Product Change Notice (PCN)

PCN Number: **PCN-0456180R-02**

Product(s) Affected: *PJ-041H*

<p>Recommended PCB Layout Top View</p>

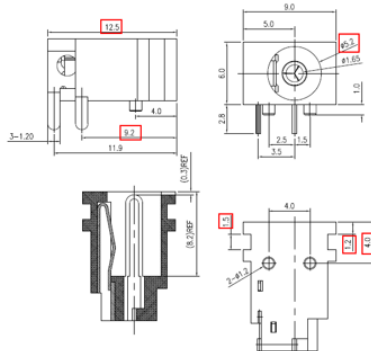
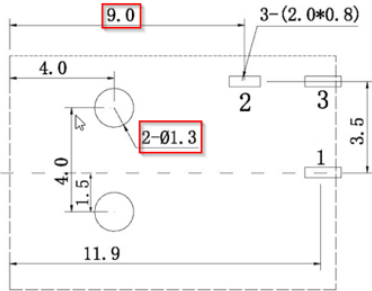
Description of Change: *New Factory Location. Product re-engineered for improved manufacturability and production yield. See image below for reference and check CUI Devices website for updated drawing. Cosmetic differences may be visible and not affect the form fit and function of the product.*

PREVIOUS CUI DEVICES DETAIL / IMAGE			NEW CUI DEVICES DETAIL / IMAGE		
DESCRIPTION	MATERIAL	PLATING/COLOR	DESCRIPTION	MATERIAL	PLATING/COLOR
center pin	brass	silver	center pin	copper alloy	silver
terminal 1	brass	silver	terminal 1	copper alloy	silver
terminal 2	C5191 phosphor bronze t=0.30	silver	terminal 2	copper alloy	silver
terminal 3	C5210 brass t=0.30	silver	terminal 3	copper alloy	silver
housing	PA66 (UL94V-0)	black	housing	PPA (UL94V-0)	black

<p>MATING PLUG Jack Insertion Depth 8.9 mm</p>	 <p>MATING PLUG Jack Insertion Depth 8.2 mm</p>
---	--
